**COMMITTEE OF THE WHOLE SEPTEMBER 13, 2011**

**SITE DEVELOPMENT FILE DA.11.040  
2174824 ONTARIO INC.  
WARD 2**

Site Plan  
Location: Part of Lot 9,  
Concession 7

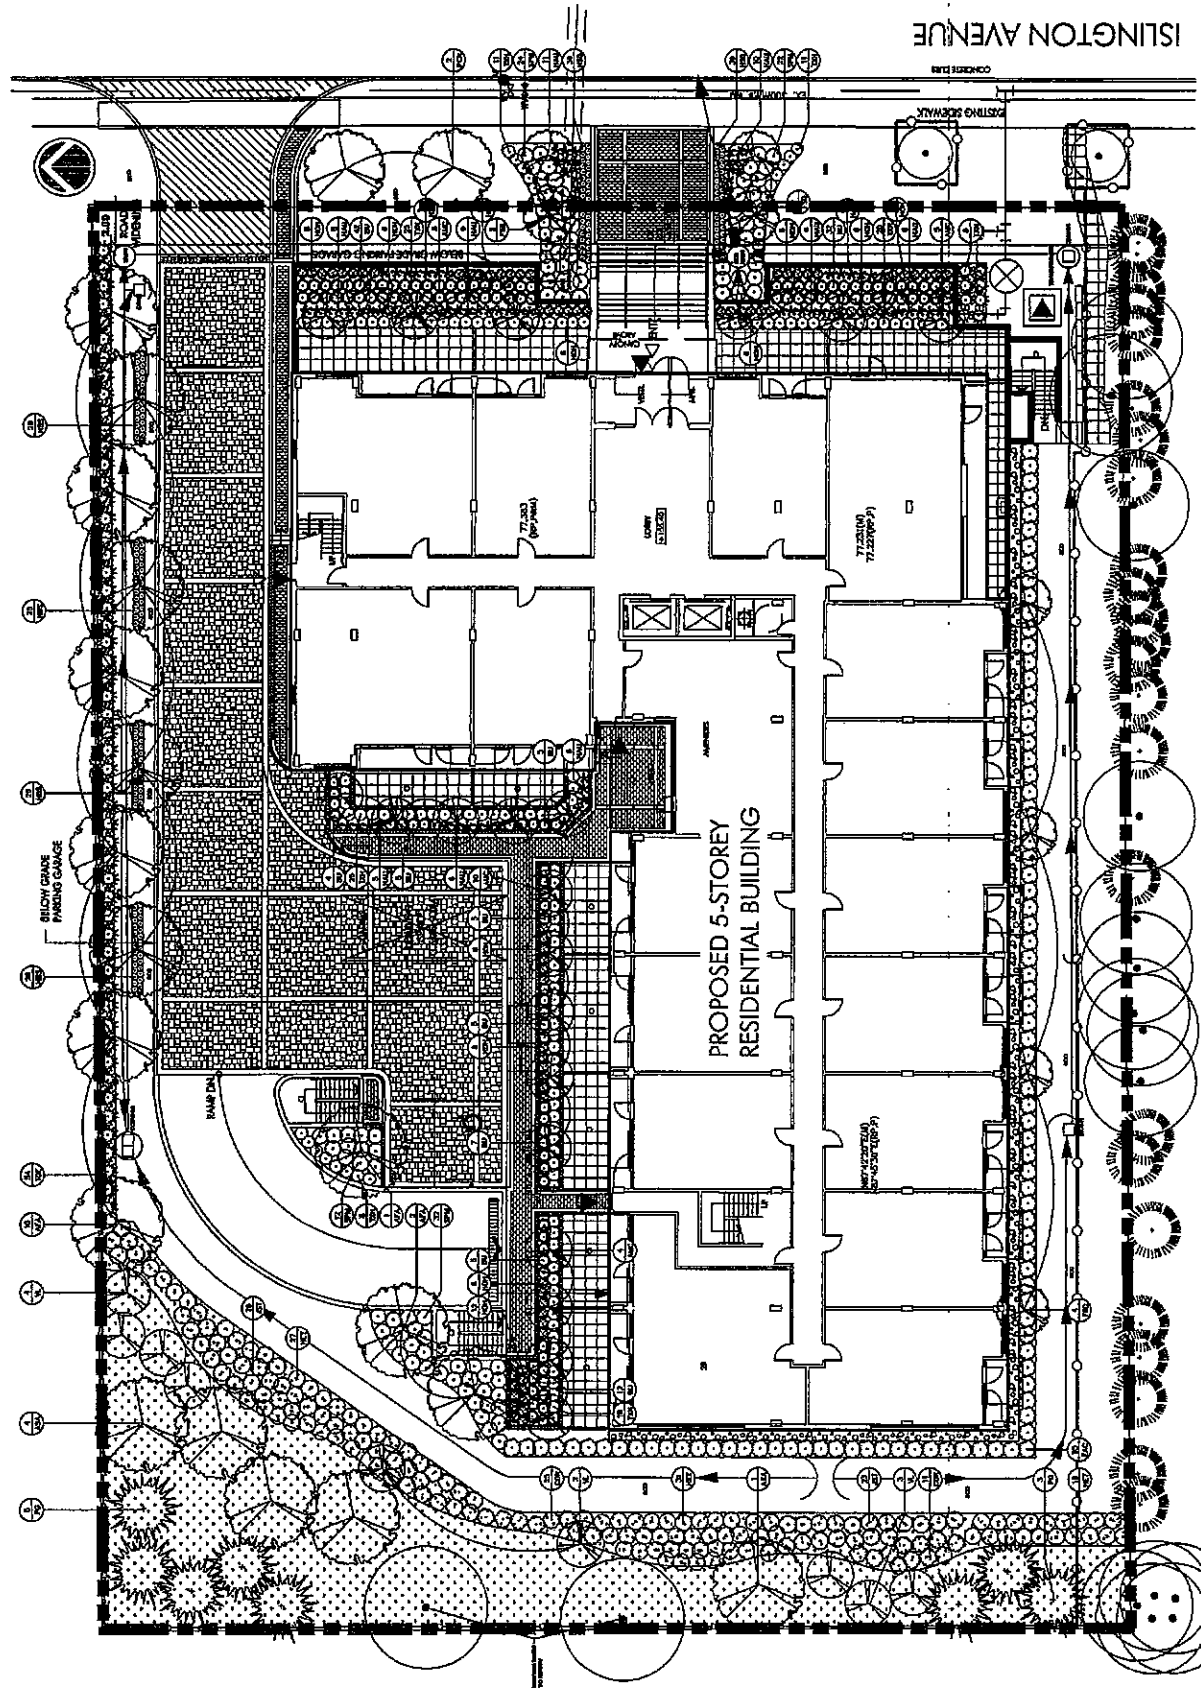
- i) the plan must be revised to show detailed statistics, including required and proposed parking spaces (resident, visitor and barrier free parking);

- ii) parking space dimensions must be shown on the site plan. The City of Vaughan standard dimensions are as follows:
  - typical parking spaces - 2.7 x 6.0
  - single barrier free space - 3.9 x 6.0
- iii) show Rb-93 "By Permit Only" signs and associated curb depressions for Handicapped parking spaces;
- iv) show Fire Route and snow storage area (2% of lot area) and indicate if snow is to be removed off site;
- v) the plan must be revised to show dimension access widths and curb radii, ingress/egress width should not be less than 7.5 m and curb radii as per City standards should not be less than 7.6m;
- vi) provide traffic signage plan (stop signs and one-way signs);
- vii) show truck maneuvering plans for garbage disposal/loading areas;
- viii) the application must be reviewed and approved by the Region of York; and,
- ix) visitor parking must be clearly identified on the Plan.

- i) There is grading within 10.5 metres of the rear lot line. It was noted as part of the negotiated settlement that there would be no construction or grading in this area, with the exception of a 1.2 metre-wide emergency walkway. The remaining area was to be naturalized. While the proposed grading appears to be minor, an explanation is required as to why this grading and the use of sod can be eliminated or reduced to respect the agreement previously reached, as reflected in Schedule 3 of the Zoning By-law.

The TRCA must assess whether or not these grading works encroach on the limit of the natural feature/hazard staked in the field by the TRCA on May 21, 2009. The limits of the natural feature/hazard should be added to all plans and cross-sections.

### A LIST OF SUSTAINABLE FEATURES

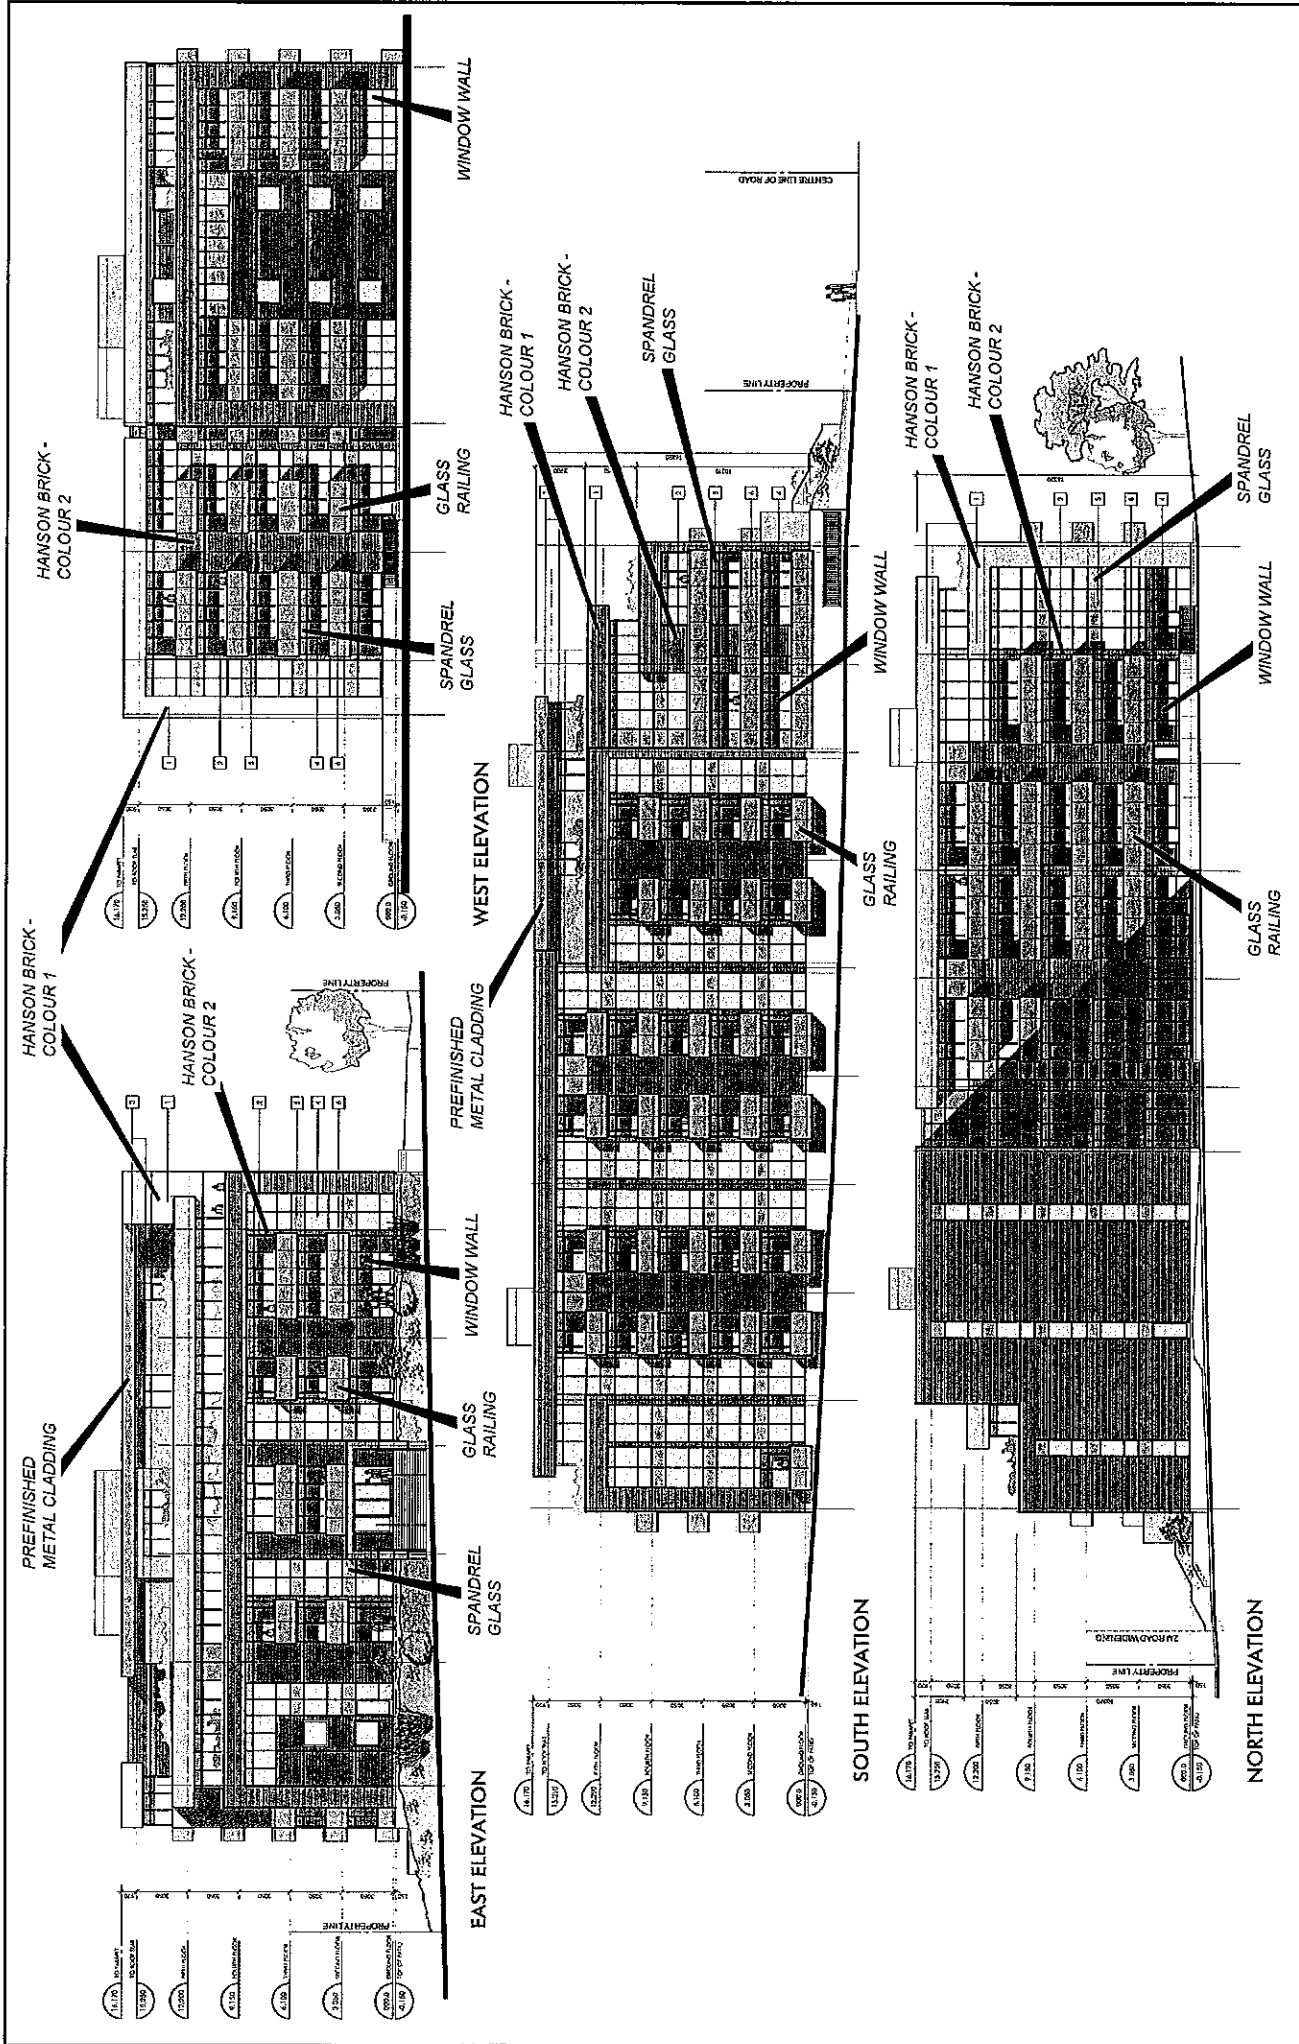
The proposed roof plan includes photovoltaic sun collecting panels instead of an extensive green roof system of sedum carpet base and additional mixed planting, which is a requirement of the OMB approved Minutes of Settlement and OPA #718. The proposed roof plan must be revised to comply with the Minutes of Settlement and OPA #718, and the applicant has been advised and will be doing so. A condition of approval to this effect is included in this report.

- iii) the roof plan shall be revised to include an extensive green roof system in accordance with the approved Ontario Municipal Board (OMB) Minutes of Settlement and OPA #718;
